26 November 2018

Our ref: 2316484  
Your ref:

**Enirgi Power Storage Recycling (EPSR) Consolidation Project EIS (SSD 6619),  
Response to Submissions Report  
Additional response to DP&E enquiries**

12(i). Annotations on relevant plans to show the process flow

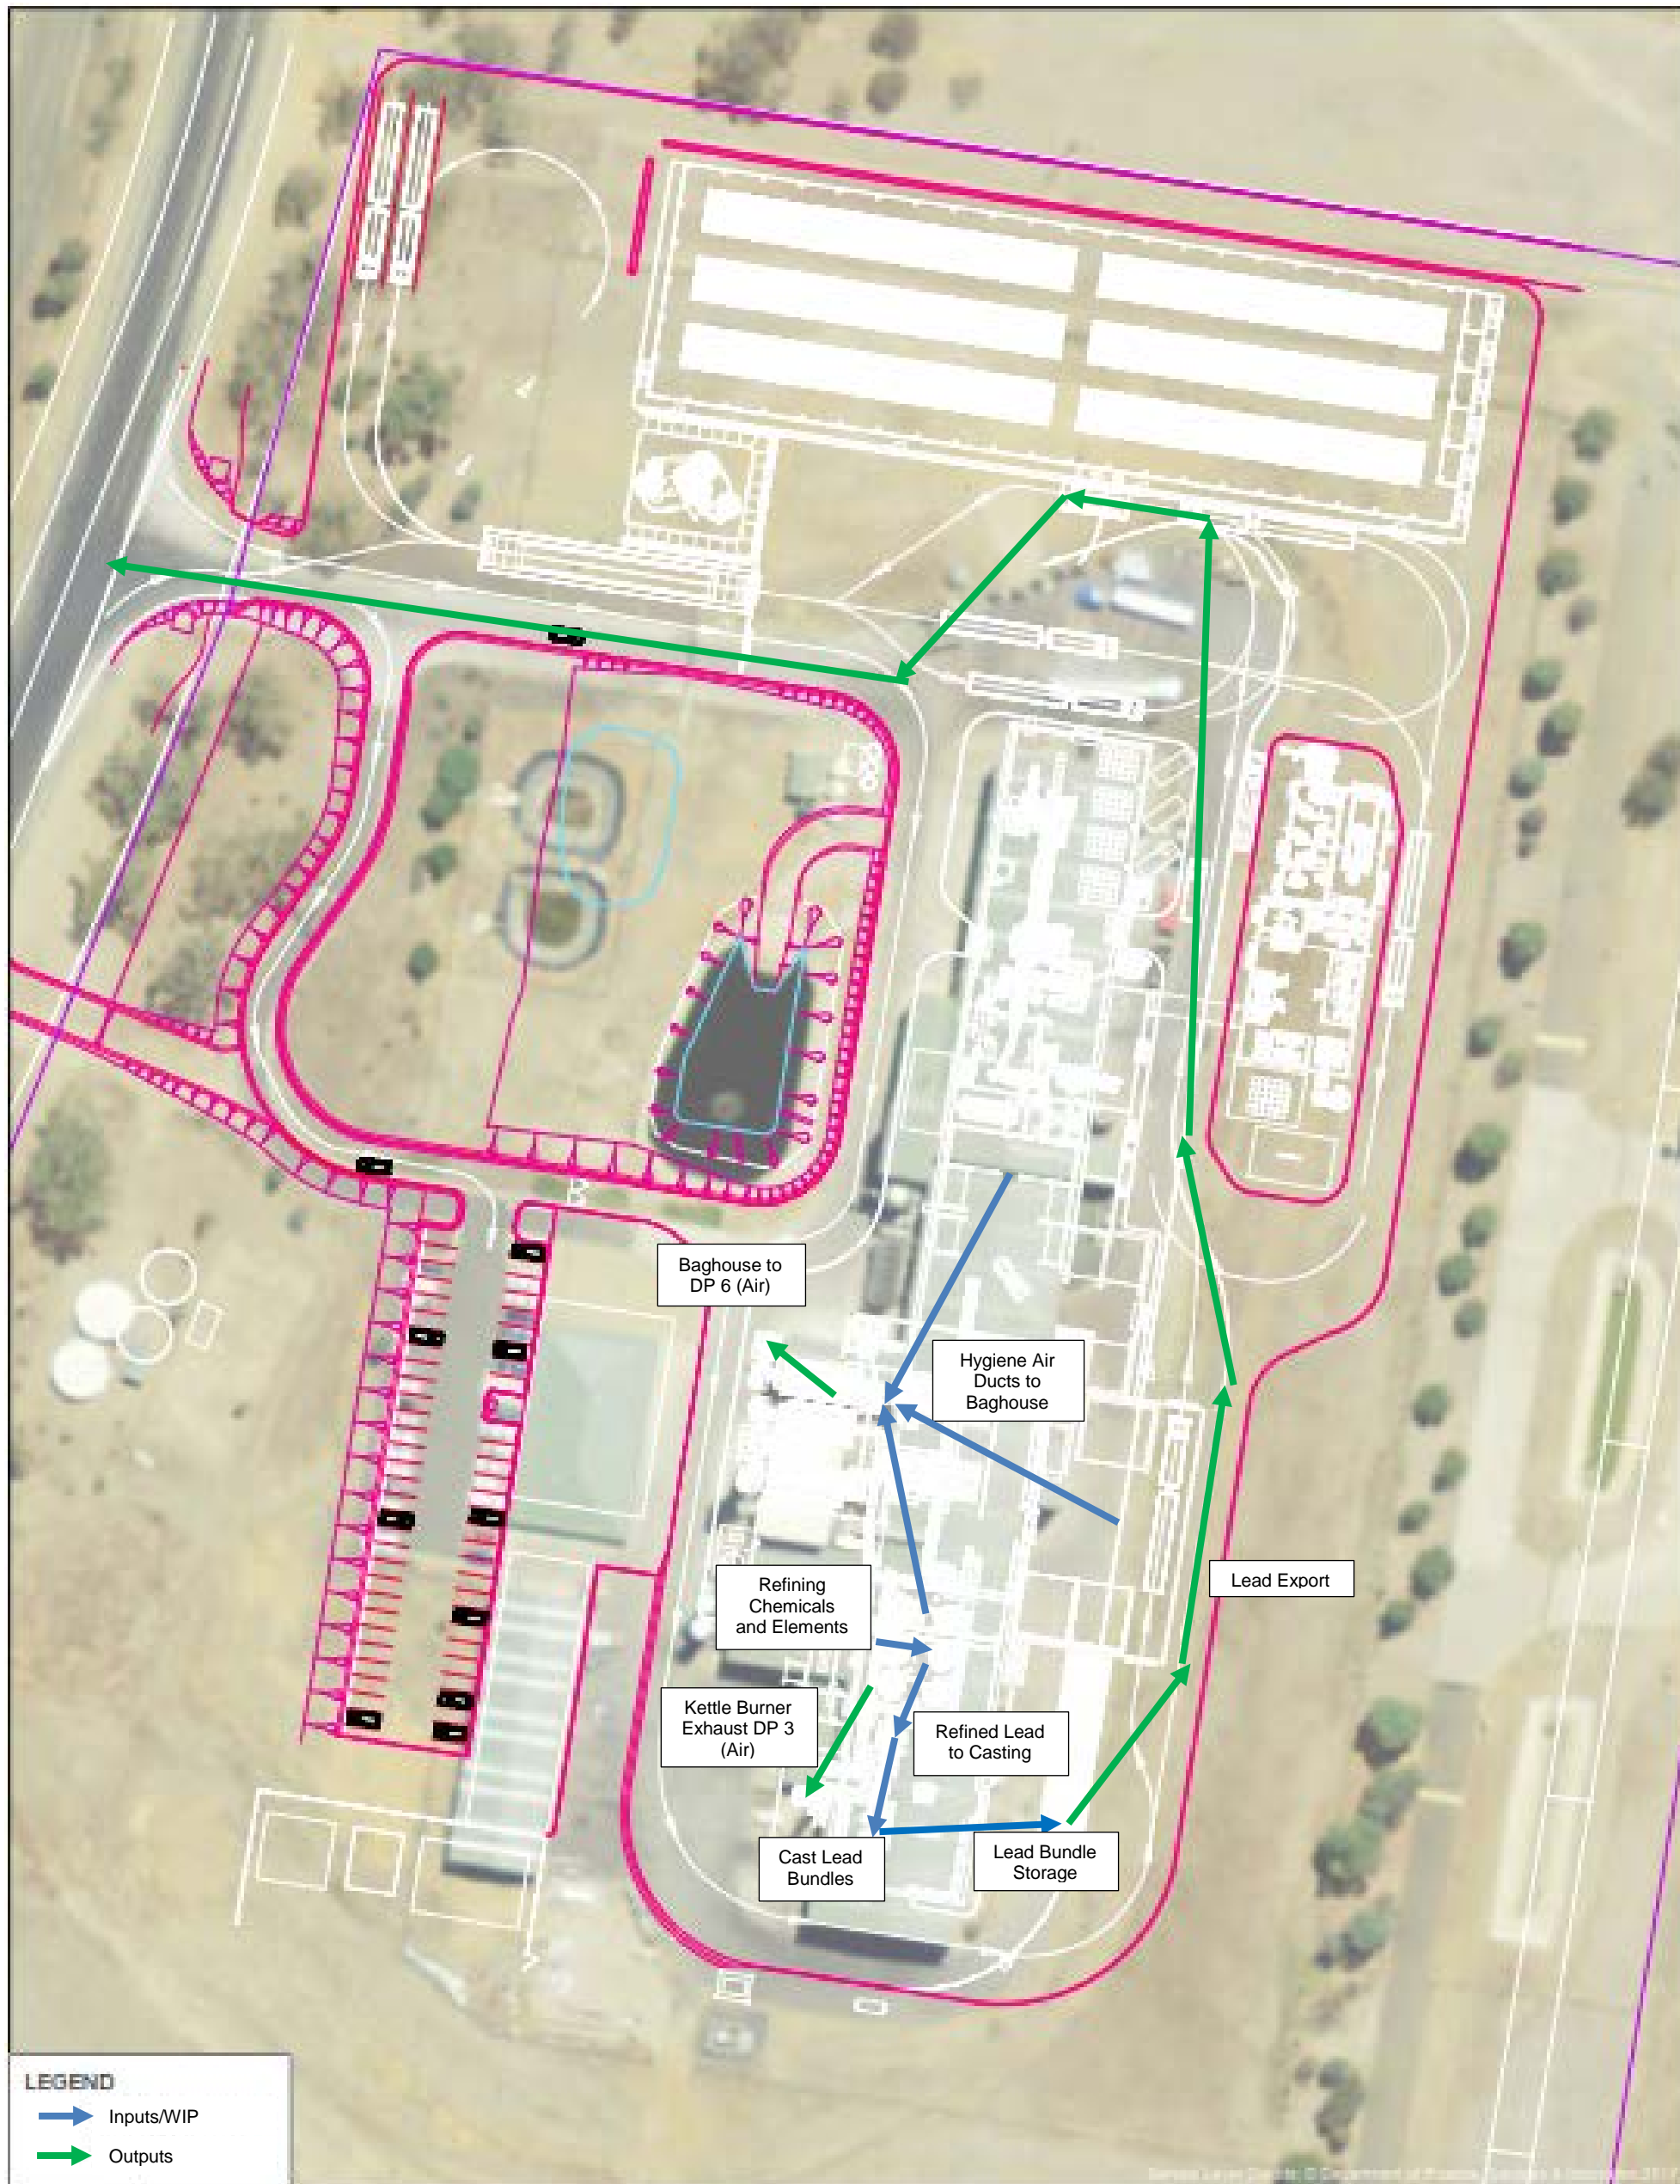
- **plans of the new internal roads**  
Provide plans of the new internal roads
- **an annotated engineering drawing of the plastics recycling facility including all components**  
Please provide
- **annotations on relevant plans to show the process flow.**  
Please provide the plan as requested above.

Detailed description of the process flow was provided in Chapter 4 of the EIS and further in the Response to Submissions Report. Additional process flow drawings have been provided as Attachment 3.
